INDEPENDENT
MARKET
OPERATOR

Draft Rule Change Report

Title: Relevant Demand of a Demand Side Programme

RC_2012_02

Figure 1: Comparison of DSP Relevant Demand Approaches (A & B)

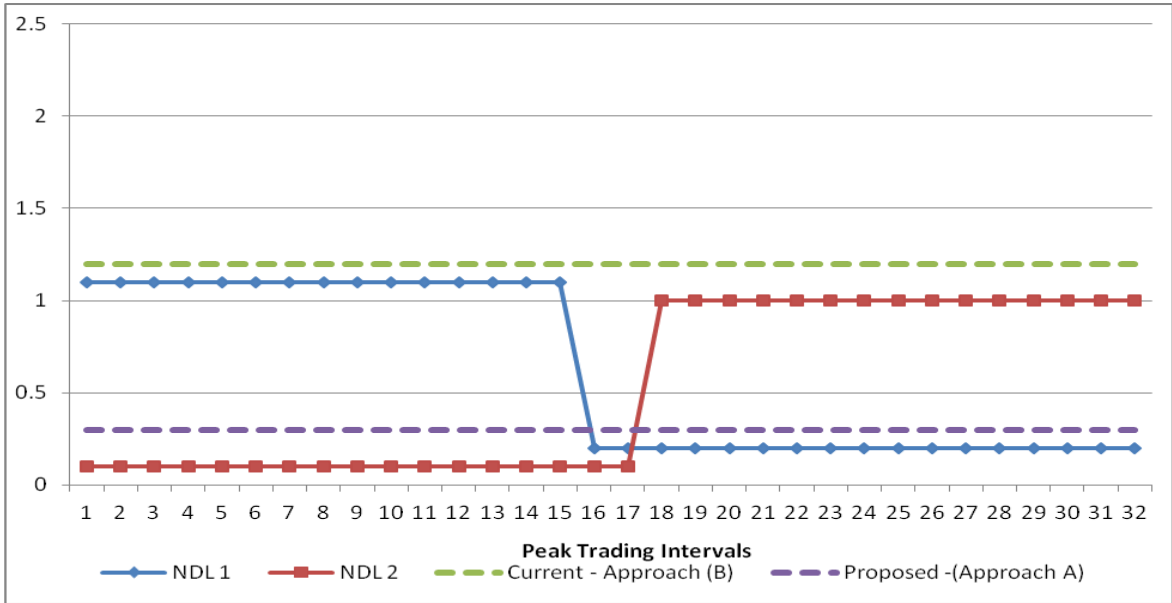
- For Figure 1, current Approach B gives a Relevant Demand result of 1.2 MW. This is a reasonable result given that the combined portfolio actually had a load of 1.2 MW for 30 of the 32 Trading Intervals. By contrast, using Approach A gives a result of 0.3 MW, a very low value which the combined portfolio only exhibited in 2 Trading Intervals.
- For Figure 2, Approach B gives a Relevant Demand of 1.2 MW, which again is a reasonable result given that the combined portfolio actually had a load of 1.2 MW for 30 of the 32 Trading Intervals. However Approach A gives a result of 2.1 MW, which the combined portfolio only reached in 2 of the 32 Trading Intervals. Most of the time the combined portfolio load was only 1.2 MW and it would seem inappropriate to use the much higher value as the Relevant Demand.

In Figure 1, the DSP's RD using Approach B is 1.2MW, whereas using Approach A, gives a result of 0.3MW – a difference of 0.9MW.

Examining the example of Figure 1, if the DSP consisted only of NDL1, the portfolio RD would be 0.2MW. Adding NDL2 increases the portfolio RD to 1.2MW. It could then be considered that NDL2 contributed 1MW, however this is inaccurate and inequitable, as the result is derived simply because they were added after NDL1. Equally, if the DSP consisted only of NDL2, the portfolio RD would be 0.1MW. Adding NDL1 increases the portfolio RD to 1.2MW. It could then be considered that NDL1 contributed 1.1MW, which again is inaccurate and inequitable.

3.	EnerNOC	<p>The examples cited in the assessment of objective (a) are deliberate extremes which could equally be interpreted as showing the degree of distortion that can occur under the current approach.</p>	<p>As discussed in section 5.1 of this report, the IMO agrees that the two examples (which were taken from the Rule Change Proposal) represent extreme cases, but notes that both show how Approach A can give an unrealistic estimate of the likely consumption of a DSP compared with Approach B. The IMO does not consider that the examples show any "distortion" under the current approach.</p>
